City of Portland, Maine - Buil	_		04-1843	12/15/2004	194 C025001
389 Congress Street, 04101 Tel: (`=		12/13/2004	
Location of Construction:	Owner Name:		wner Address:		Phone:
1407 Congress St	Vacation Properties Ir	nc 3	349 South St		
Business Name:	Contractor Name:		ontractor Address:		Phone
	Edward Jackson	2	22 Vines Road Sac	0	
Lessee/Buyer's Name	Phone:	P	ermit Type:		
		<u> </u>	Duplex		
2 Family home 2 1/2 story 3140 sq.ft.	of living space	2 Famil	y home 2 1/2 story	/ 3140 sq.ft. of livin	g space
Dept: Zoning Status: A Note: 1/14/05 Actually on hold - tal the size of the rear bulkheads 1/18/05 received revised plan	- coming in on Tues wi	added fireplaces	Marge Schmucka

#0 - 1843 1405-09 Congress St 194-C-25

RE: Application for Minor Site Plan, 1415 Congress Street Duplex

FIRST FLOOR PLAN

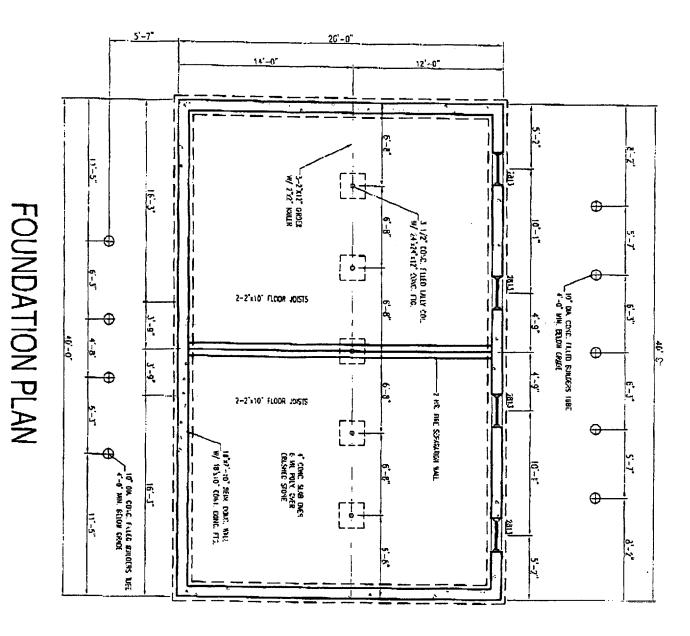
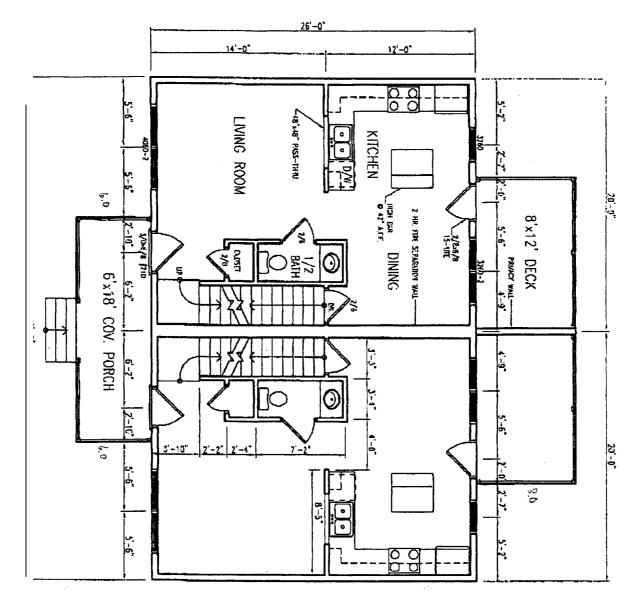
3) This permit is being approved on before starting that work.	the basis of revised plan	ns submitted on 1/	18/05 Any deviat	ions shall require a	separate approval
Dept: Building Status: A	pproved with Condition	ns Reviewer:	Jeanine Bourke	Approval D	ate: 01/20/2005
Note: 1/18/05 spoke w/Ed J. About 1/19 spoke w/Ed J. For detail waiting for DRC approvals.	site plan approvals, gav s on the review checklis	ve him Jay R. Telest. He will bring i	: #. n items, and verifie	ed some on list. Als	Okto Issue:
Permit approved based on the plannoted on plans.	ns submitted and review	ed w/owner/contr

SECOND FLOOR PLAN

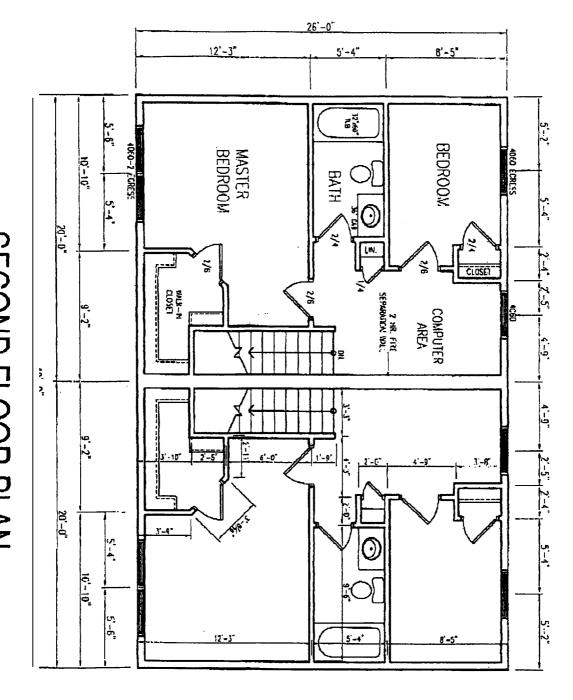
2) Separate permits are required for	any electrical, plumbing		NEEDI	1×17 4 1>T	4 2nd Flour Pla
Dept: Fire Status: A Note:	pproved	Reviewer-	Lt. MacDougal	Approval D	ok to Issue: ✓
Dept: DRC Status: A Note:	pproved with Condition	ns Reviewer:	Jay Reynolds	Approval D	ate: 0912212004 Okto Issue:
